ITB16-018a

VOLUNTARY SAFETY RECALL CAMPAIGN OCCUPANT CLASSIFICATION SYSTEM CONTROL UNIT REPLACEMENT

This bulletin has been amended to add battery disconnection steps to the Service Procedures. No other changes have been made. Please discard the previous versions of this bulletin.

CAMPAIGN ID #: R1606
NHTSA #: 16V-244
APPLIED VEHICLE: 2013 JX (L50)
2014-2016 QX60 (L50)
2014-2016 QX60 Hybrid (L50)
2014-2016 Q50 (V37)
2014-2016 Q50 Hybrid (V37)

Front Passenger Air Bag Status Light

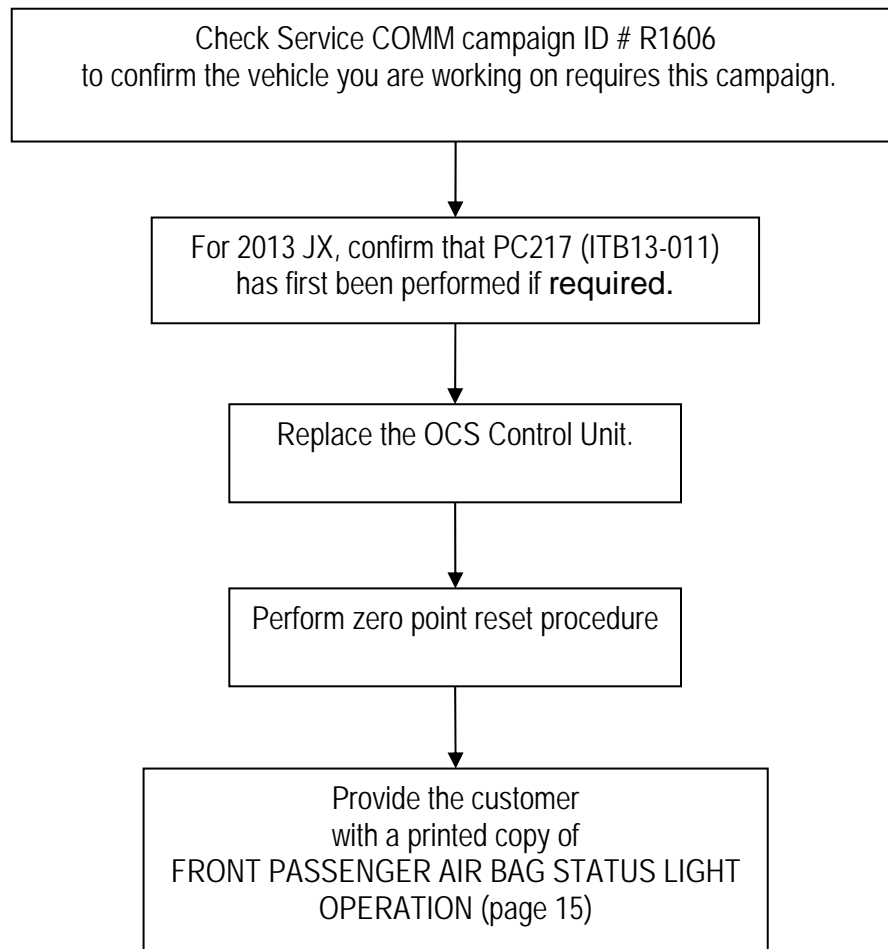
Performing the procedures in this bulletin (campaign R1606) changes the operation of the passenger air bag status light.

- After performing this campaign, the passenger air bag status light will be ON (illuminated) when the front passenger seat is empty.
